ADDENDUM No. 3

ITB No. 4657

West Gallup Park Path Resurfacing

DETAIL 7: SEATING AREA

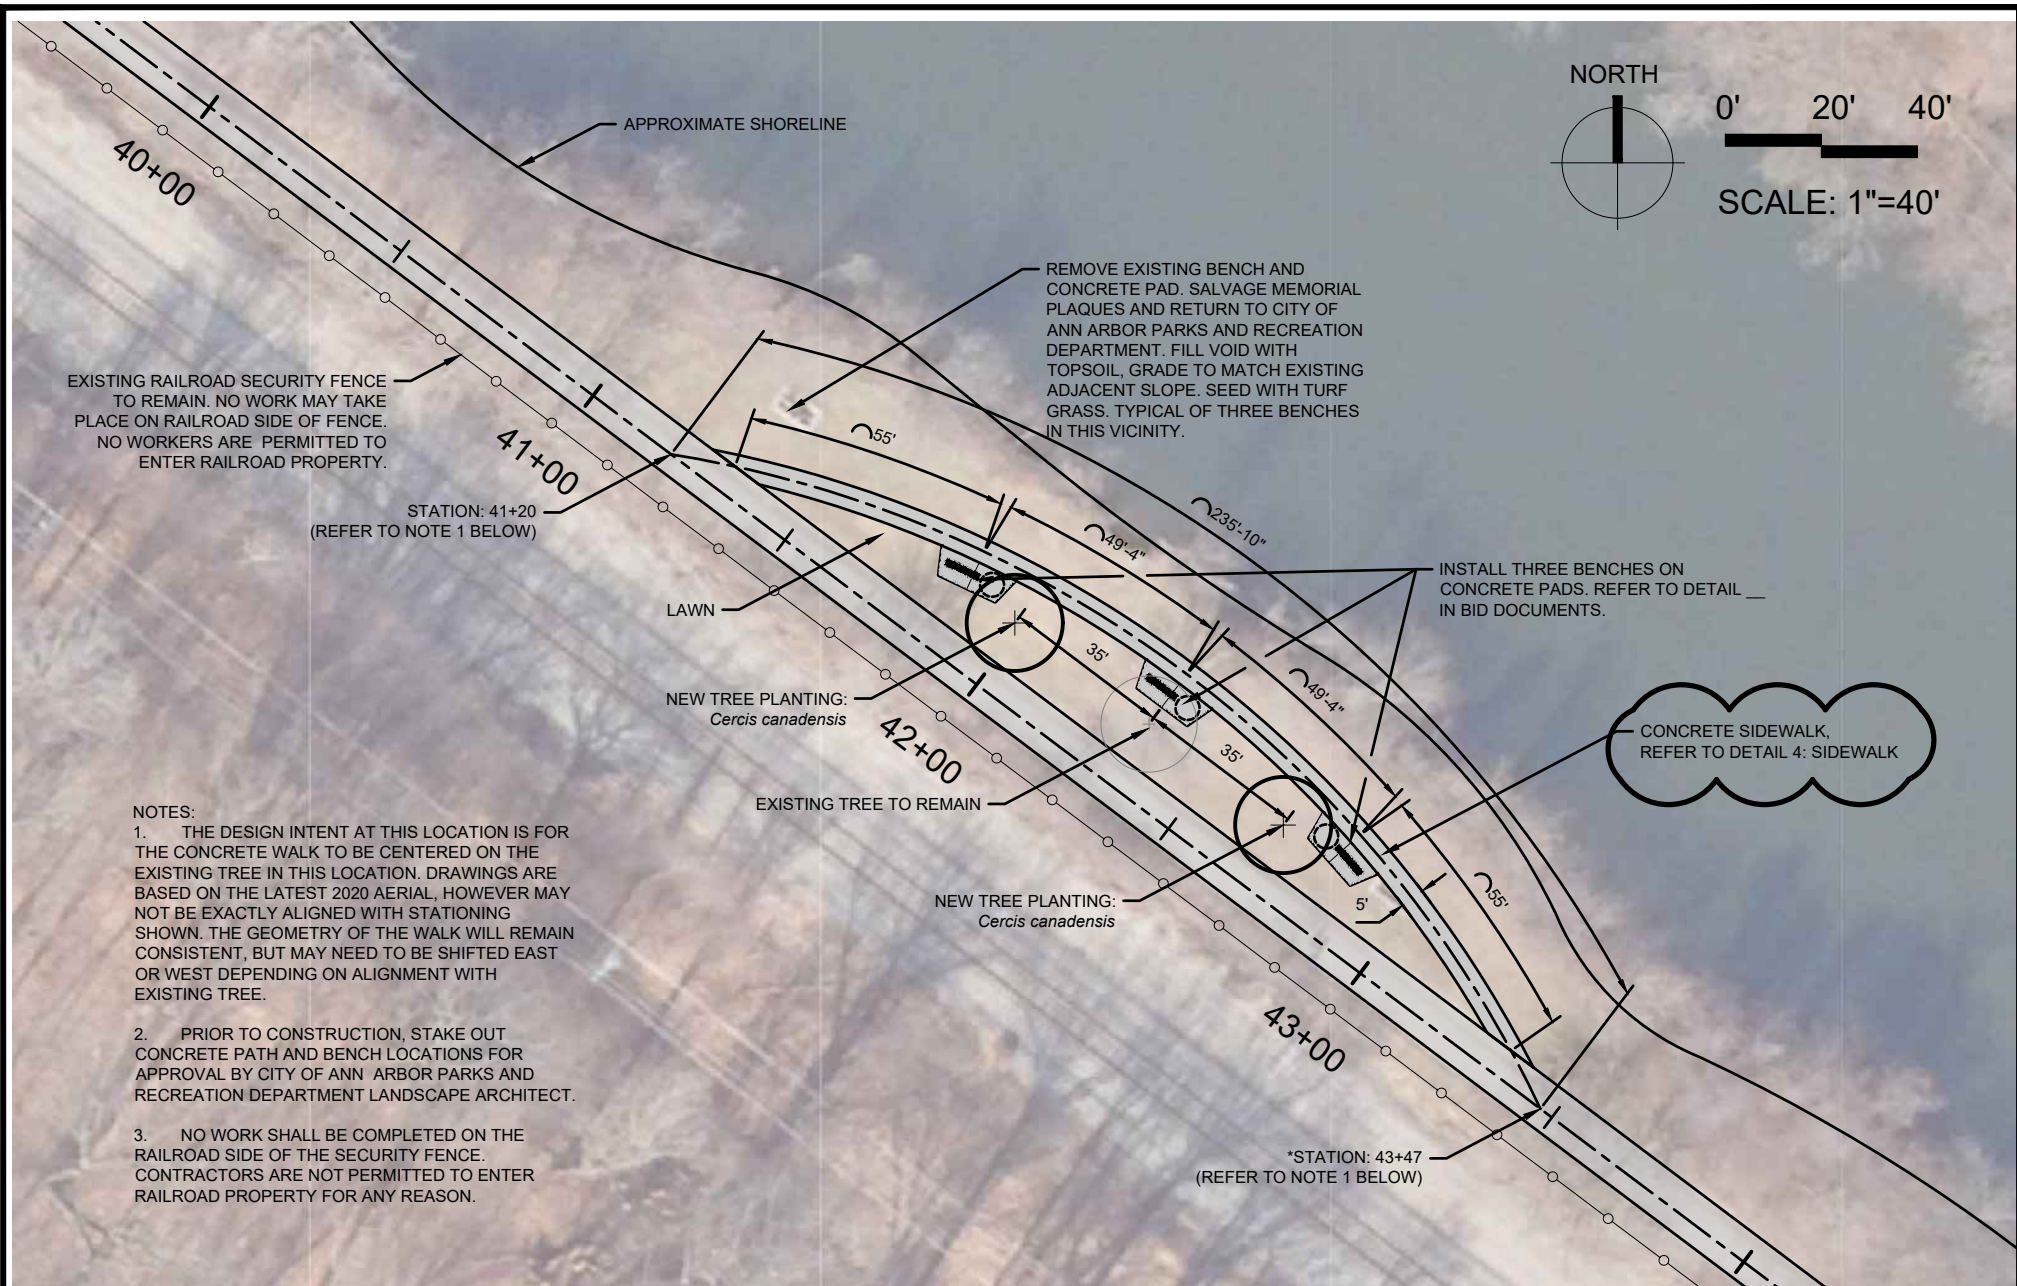
DETAIL 7:

As provided in ITB No. 4657 Bid Document:

SEATING AREA

Concrete Walk – Refer to Concrete Paving Detail in Bid Documents

Comment: This change was made to clearly reference the concrete sidewalk detail in the ITB documents, and match language found on sheets BF-2 and BF-4.

As updated herein:

Concrete Sidewalk, Refer to Detail 4: Sidewalk
